Permit Type Building/Residential/Misc/Pool Spa Permit Number B24004276 Opened Date 11/11/2024
Description of Work SFD/Install 18x38 inground swimming pool to be 3 1/2 to 7' deep. Pool to be equipped with an automatic safety cover in lieu of a fence.**APPROVED FOR AUTOMATIC POOL COVER IN LIEU OF FENCE. SUBJECT TO FIELD INSPECTION**

SITE PLAN - B

Kline Residence

PLAN SHOWING A PROPOSED SWIMMING POOL
PARCEL 1
 KEYES PROPERTY SUBDIVISION
 PLAT NUMBER 15813
 KLINE PROPERTY, LIBER 20645, FOLIO 307
 TAX MAP 14, GRID 1, PARCEL 160
 4th ELECTION DISTRICT, HOWARD COUNTY, MARYLAND
 SCALE: 1" = 40'
 JOB NO.: 3686
 DATE: OCT. 18, 2023
 SHEET: 1 OF 1

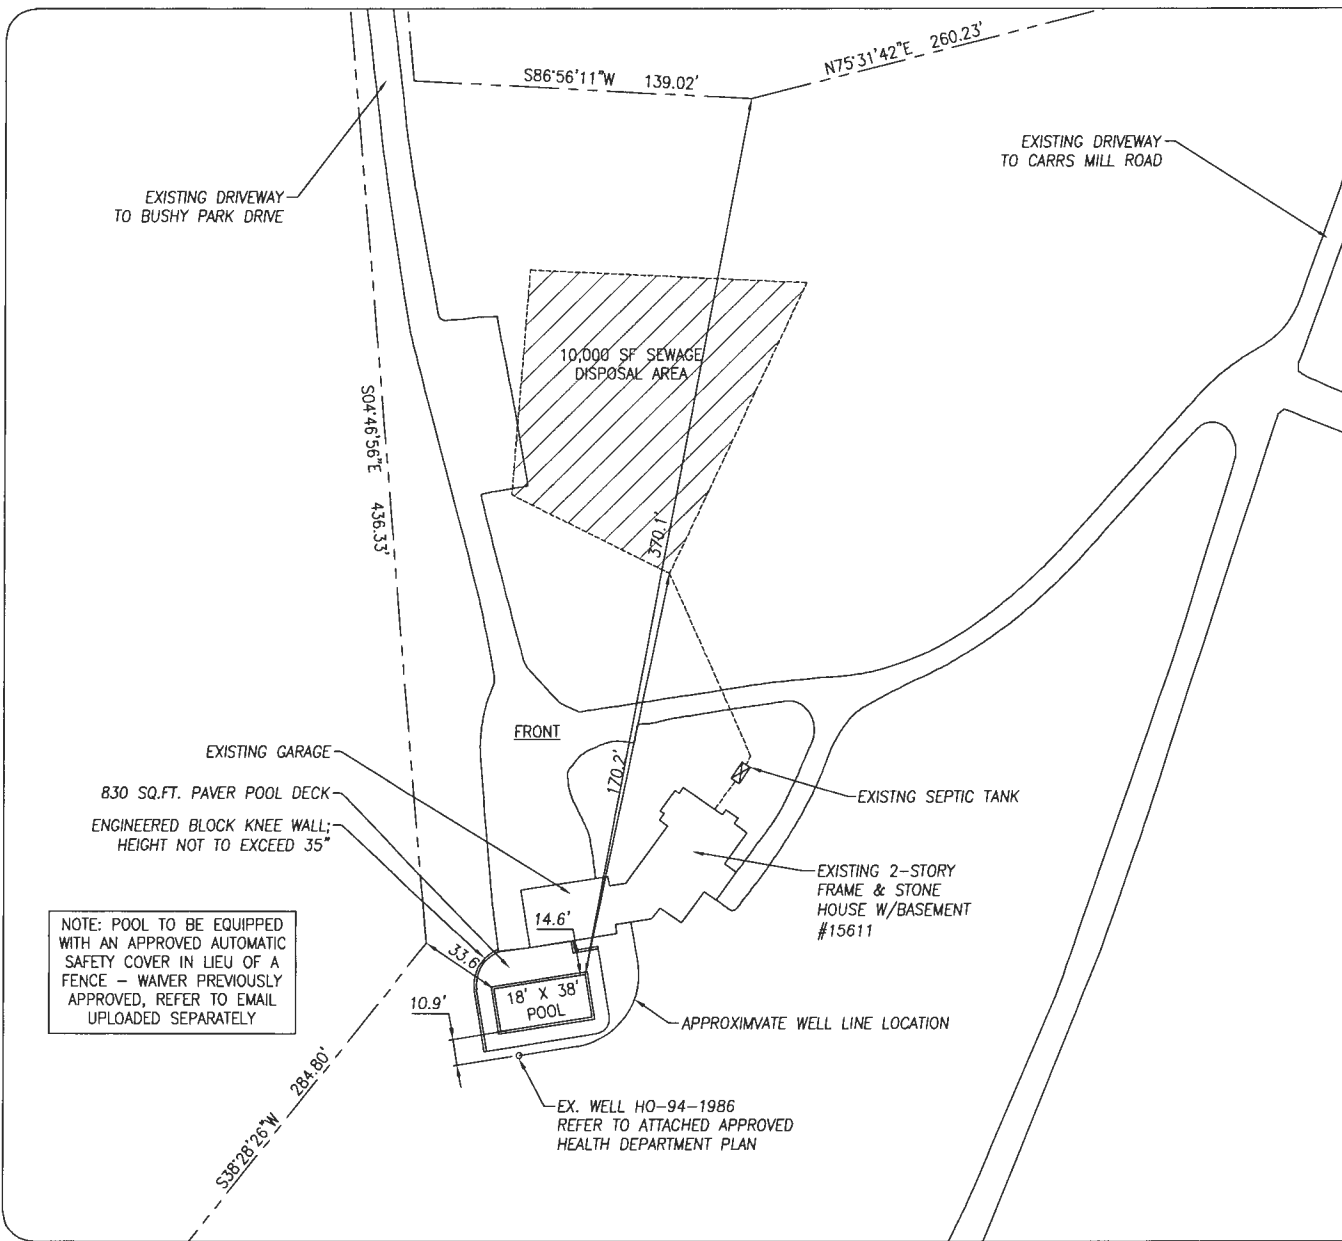
After review of the building permit (B24004276) site plan, proposed work, and health department records, we kindly request that you submit a revised plot plan to scale. The plan needs to show the pool equipment location, dirt spoil pile location and access to ensure that the vehicle equipment excavation process does not interfere with the well/well water line or the Sewage Disposal Area (SDA). Additionally, there is a minimum setback requirement of 20' from the pool to the well and 10' from the well line to the pool project. Prior to approval of the building permit, a site visit will be made to the property to confirm the setback distances from the well/water line to the proposed pool and will require the well/water line, and pool to be staked in advance. Please let me know if you have any questions and thank you kindly.

We will provide the revised site plan showing access, pool equipment location and dirt spoils location.

The well line has not been moved and is anticipated prior to pool construction.

SITE PLAN - A

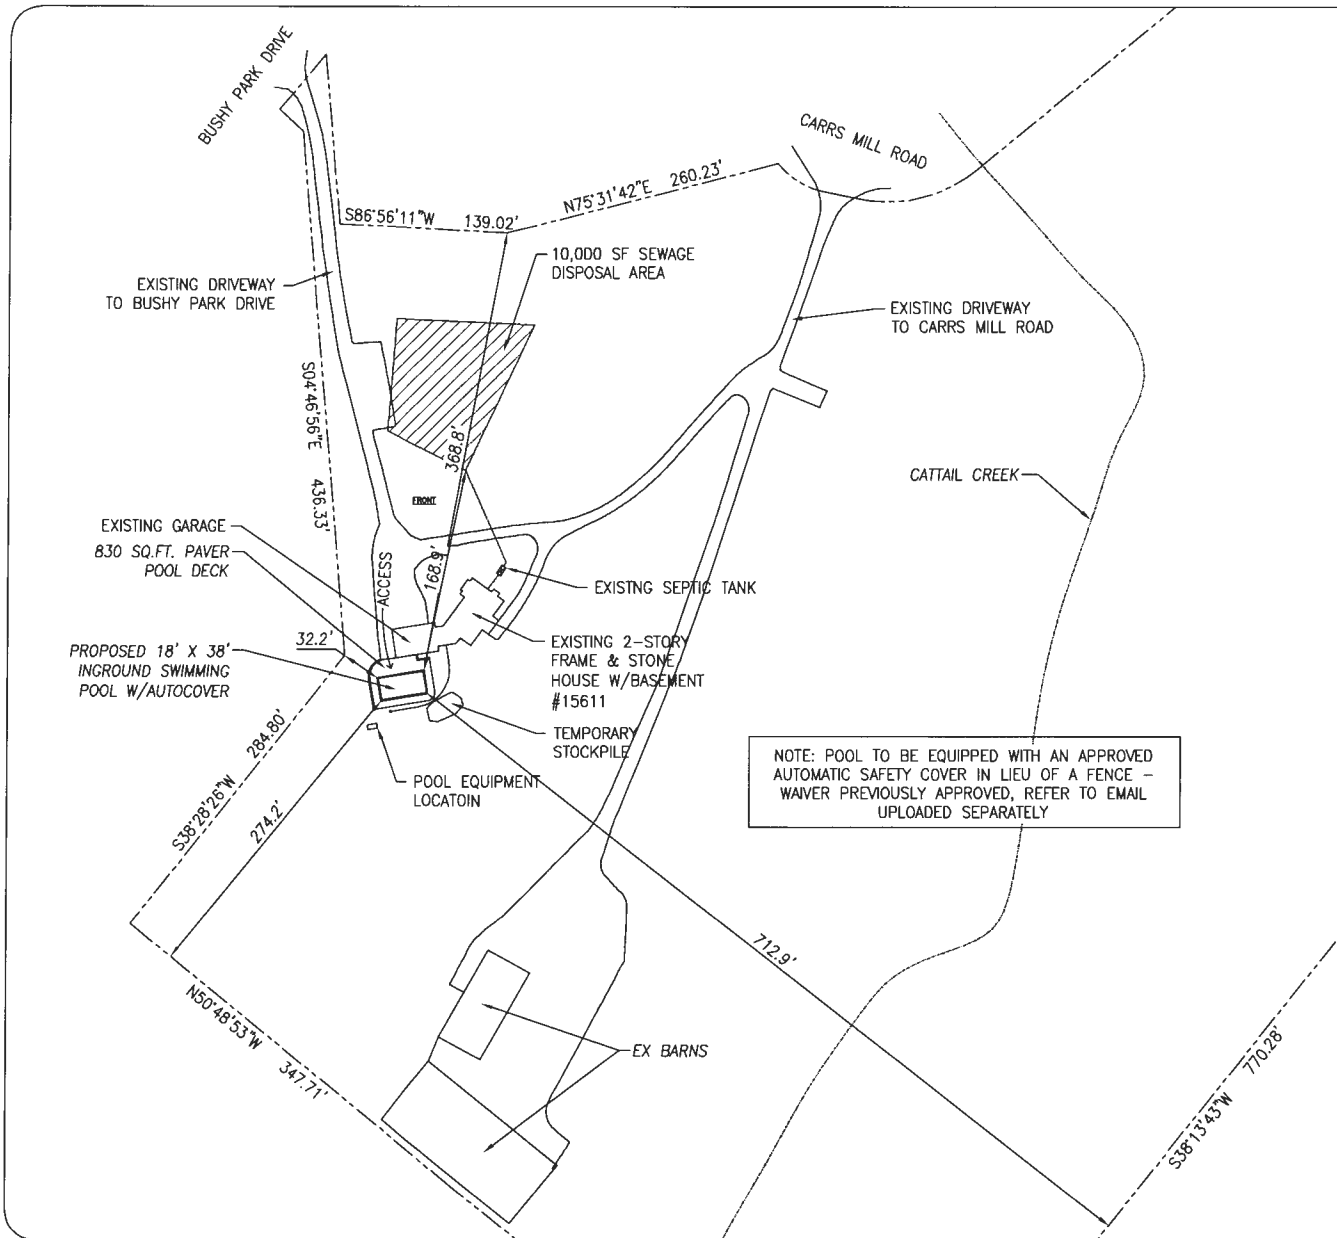
I am following up regarding the review of the revised site plan and wanted to confirm whether the well line has been relocated for this property. Please confirm whether this well line relocation is underway and if so, have the contractor call a well line inspection in our office at 410-313-1771. Once this process has been completed, I can

schedule a site inspection and confirm setback distance and the installation of the “high profile fencing” around the well in advance of HD building permit approval. Please let me know if you have any questions and hope you have a nice afternoon.

The well line is going to be moved on or about Jan 6th. Contractor is pulling permit for relocation and fencing and pool will be staked out for inspection prior to excavation.

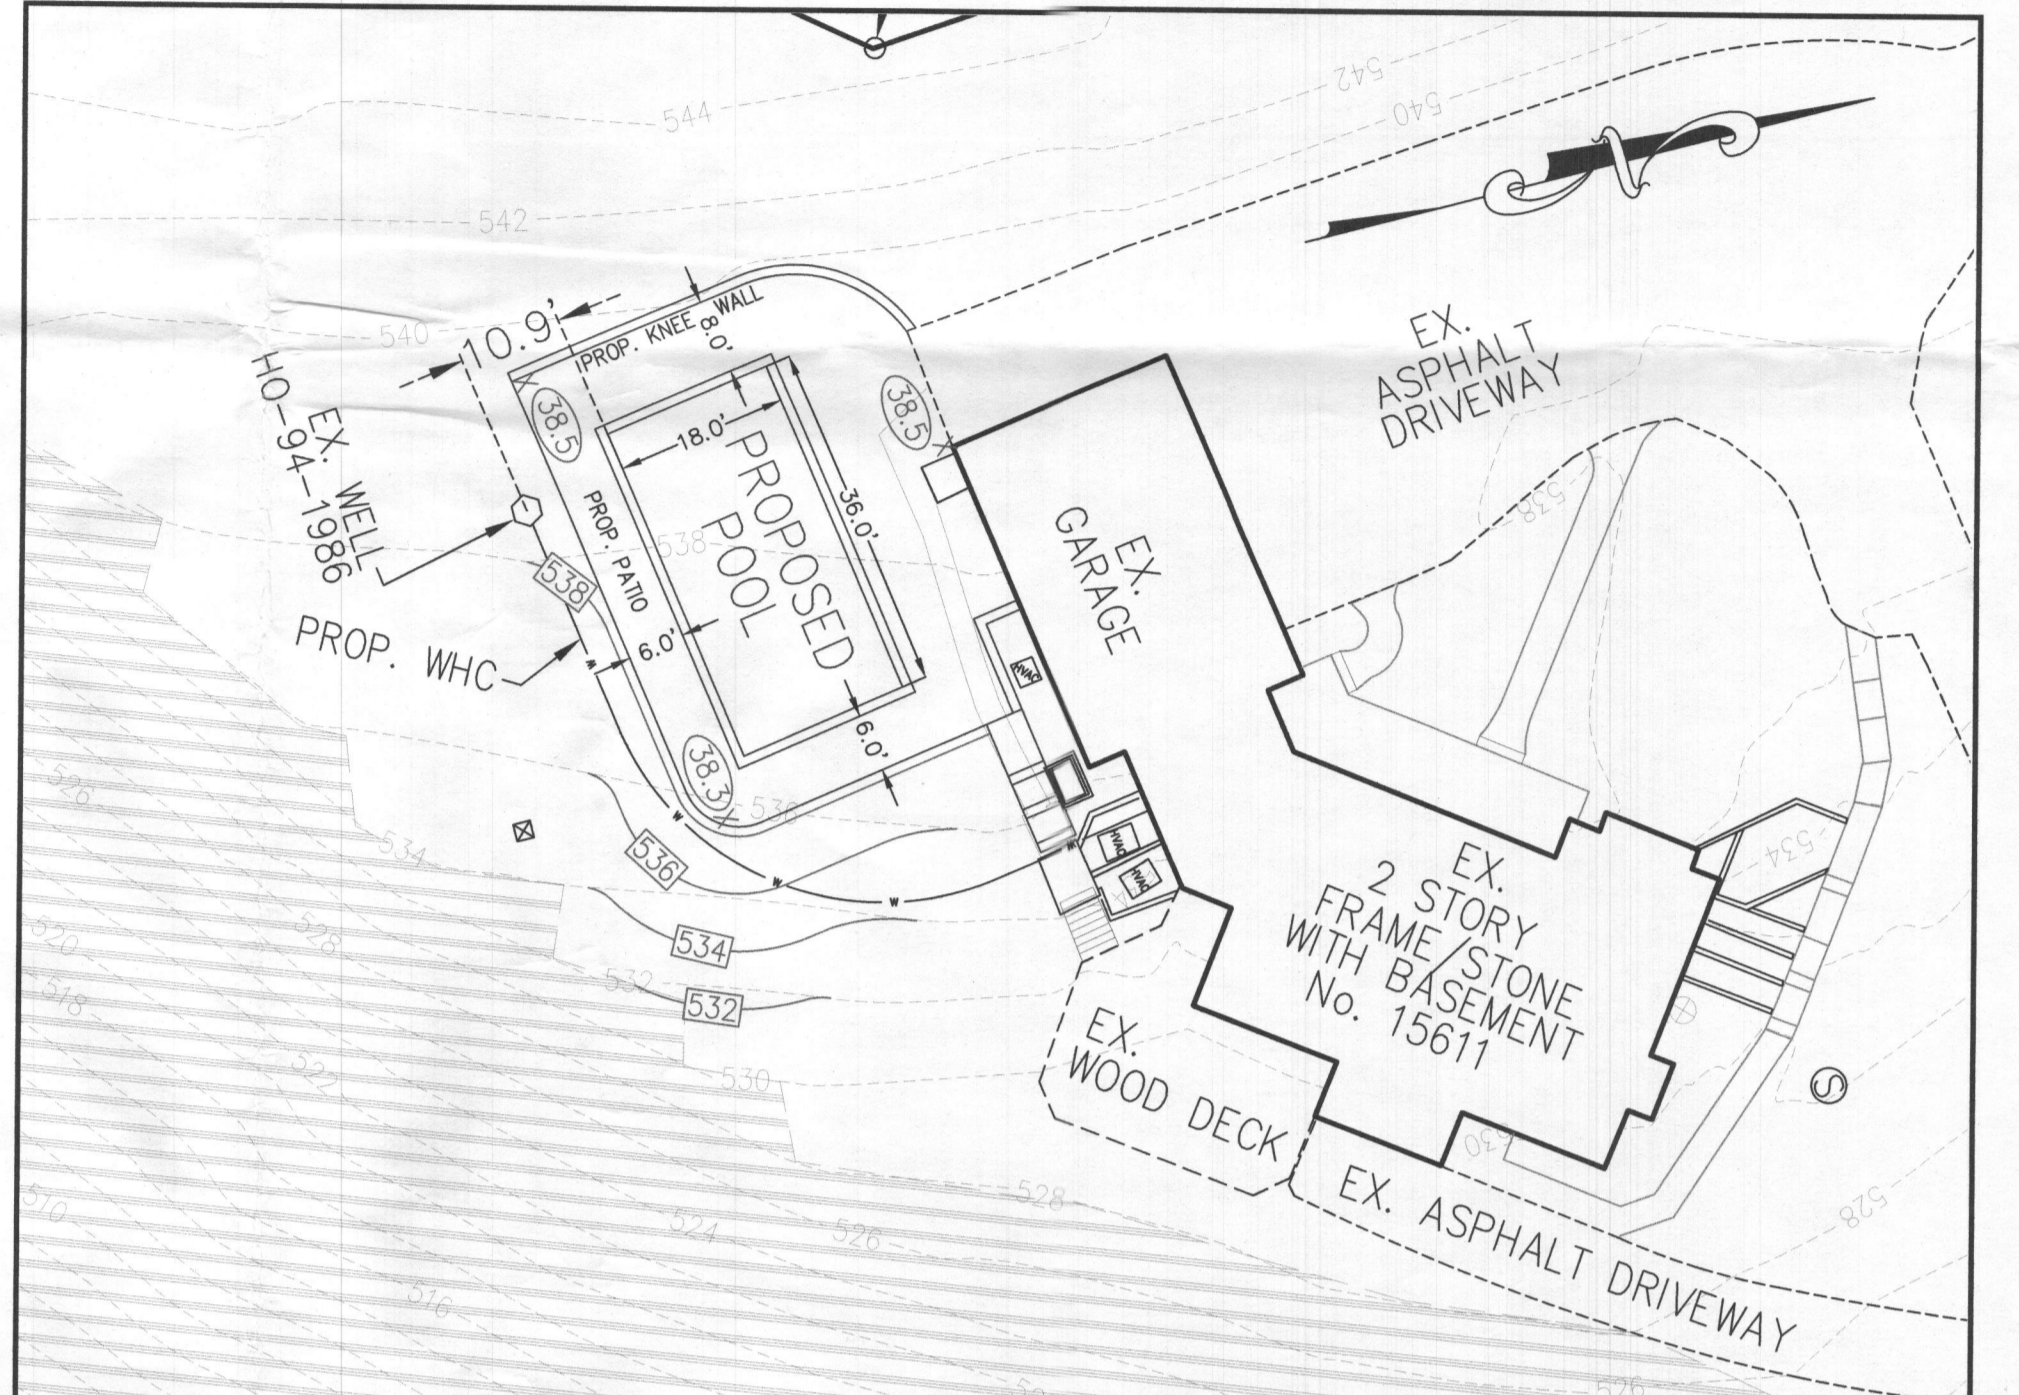
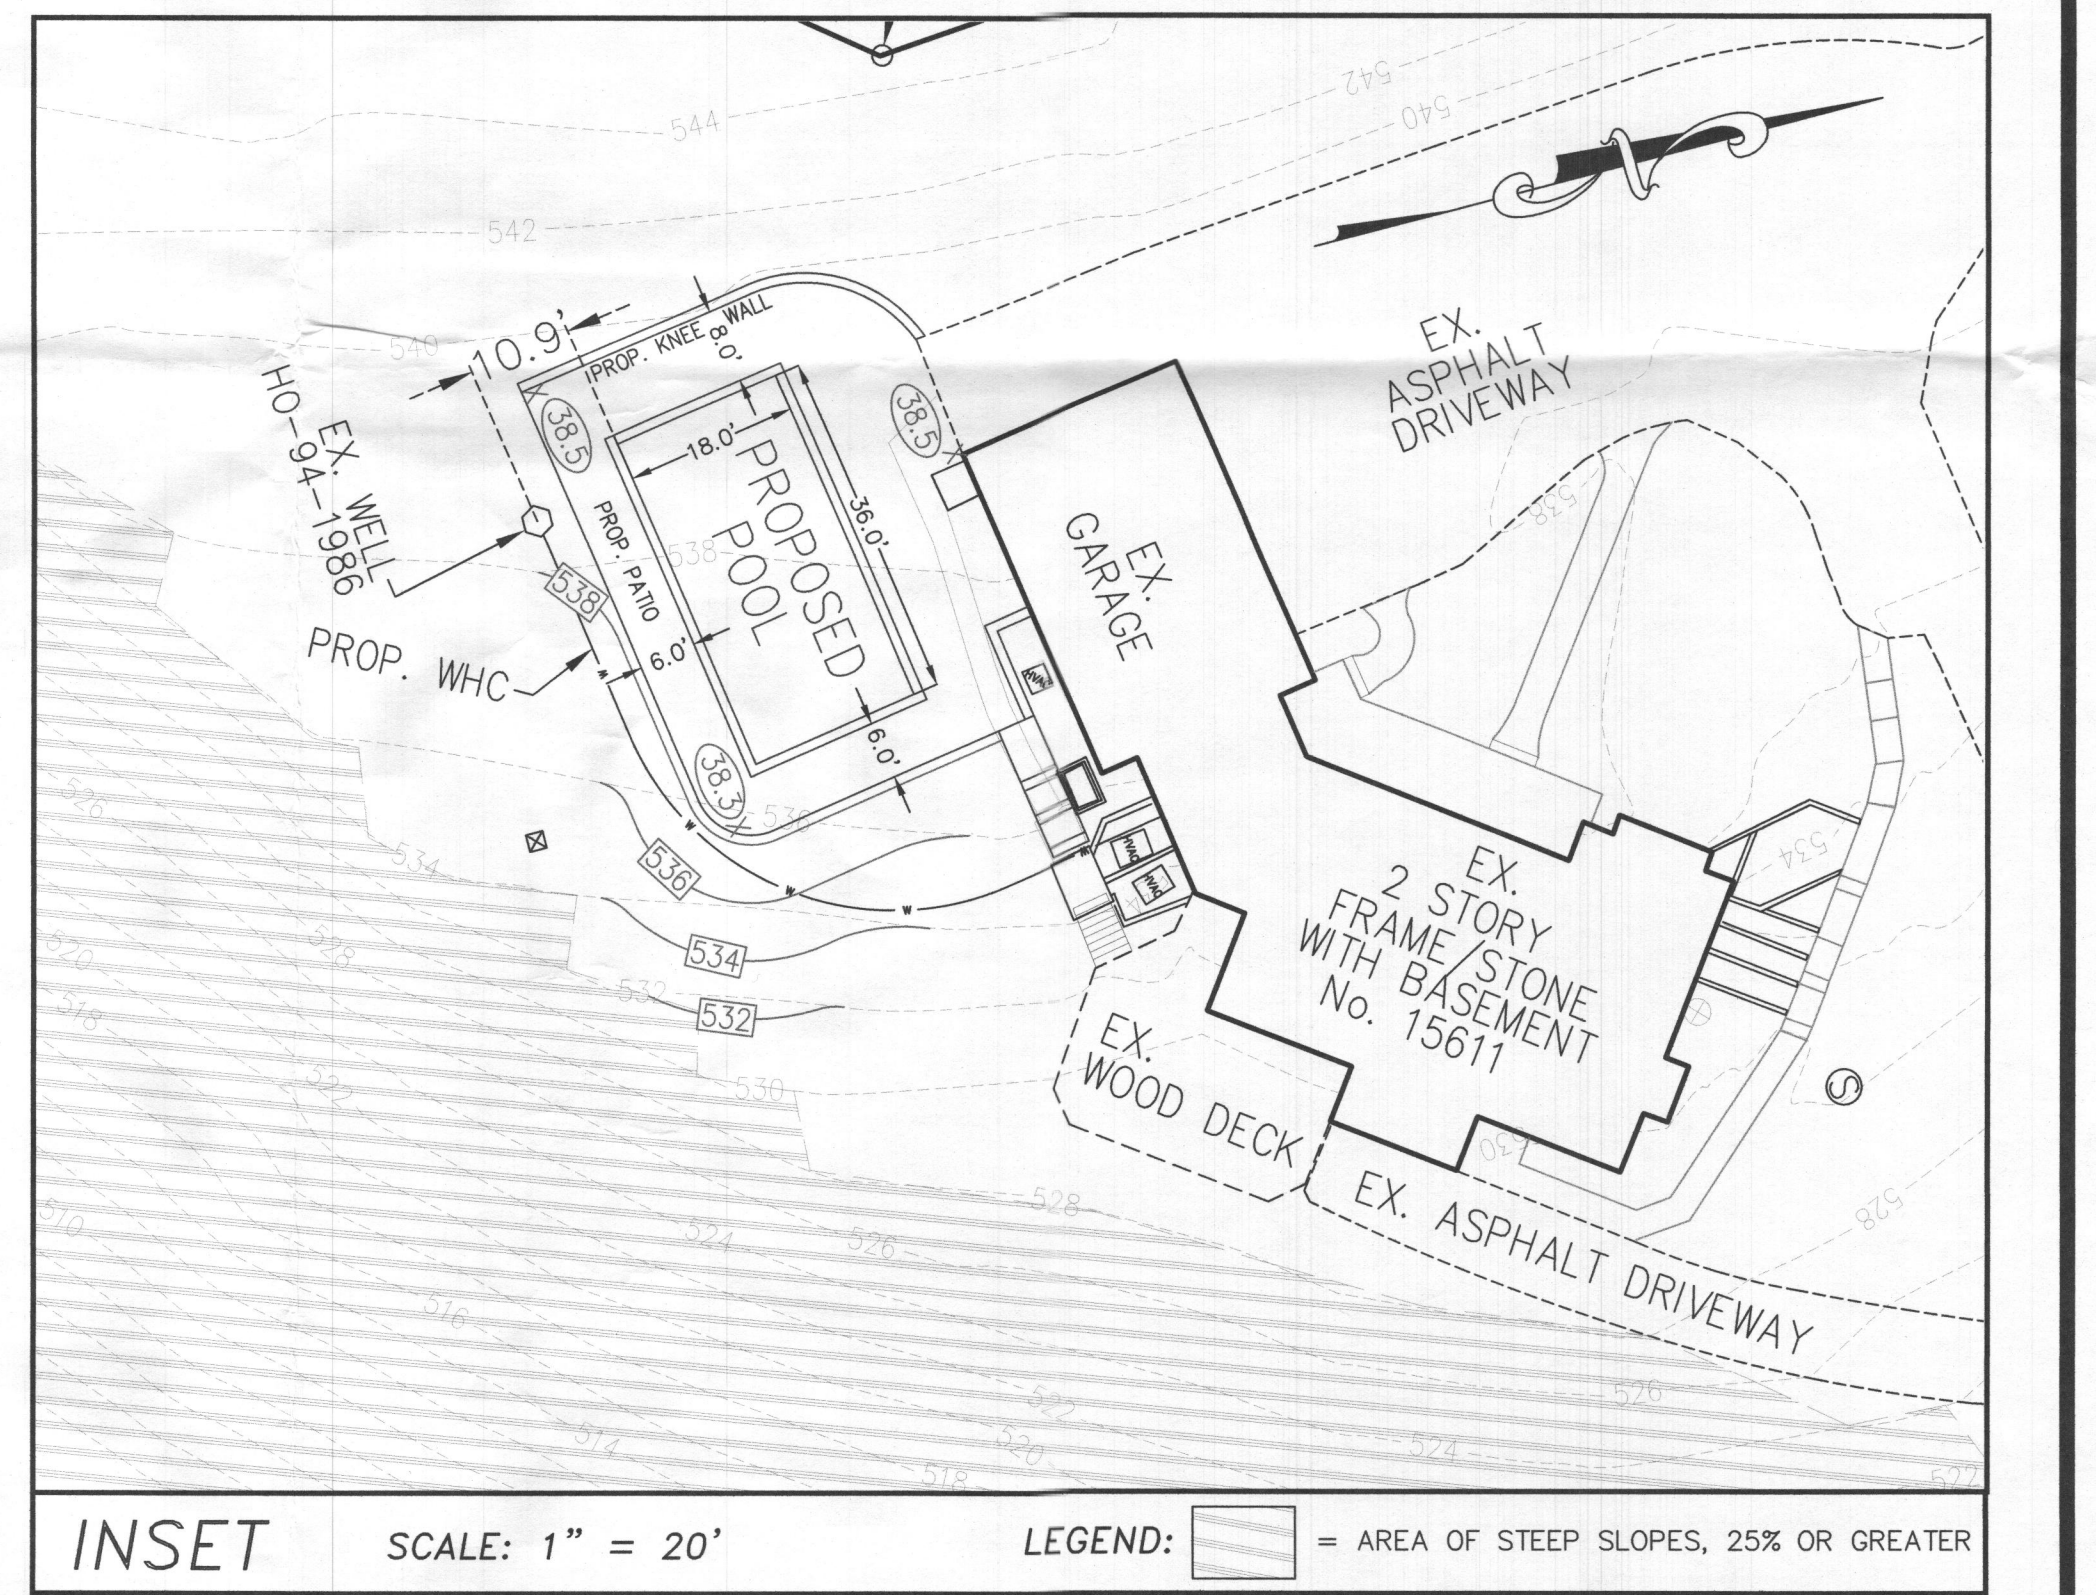
We are hoping to request the installation of 18'x36' pool and hardscapes as shown on the plan attached, with a variance for a 10' setback from the well. This would place the pool on the most level area, giving us the best view of the pool from all areas of our backyard. This plan will also require significantly smaller retaining walls, and will also ensuring our deck is not in the picture at all for the safety of our children and their friends.

Hello. After reviewing the proposal and Dana's site visit, I'm approving your waiver for the pool in the location shown. We will require the well to be fenced with sturdy, high profile fencing prior to us signing off on the building permit application to make sure the pool people see the well and don't damage it or put the soil pile on it. The pool people should identify the area where they will place the spoil pile on the building permit plot plan so we can verify it is not in conflict with the well or sewage disposal system components.

You are proposing to relocate the well line. That should be done before the pool installation, so if its done before the building permit application, that would avoid any delays. Please note that the well line should be called in to our office by the plumber for inspection. You will need to chlorinate the well after the well line work to get the water potable again. Let me know if there are any questions. Thanks
Jeff

approved
12/13/23
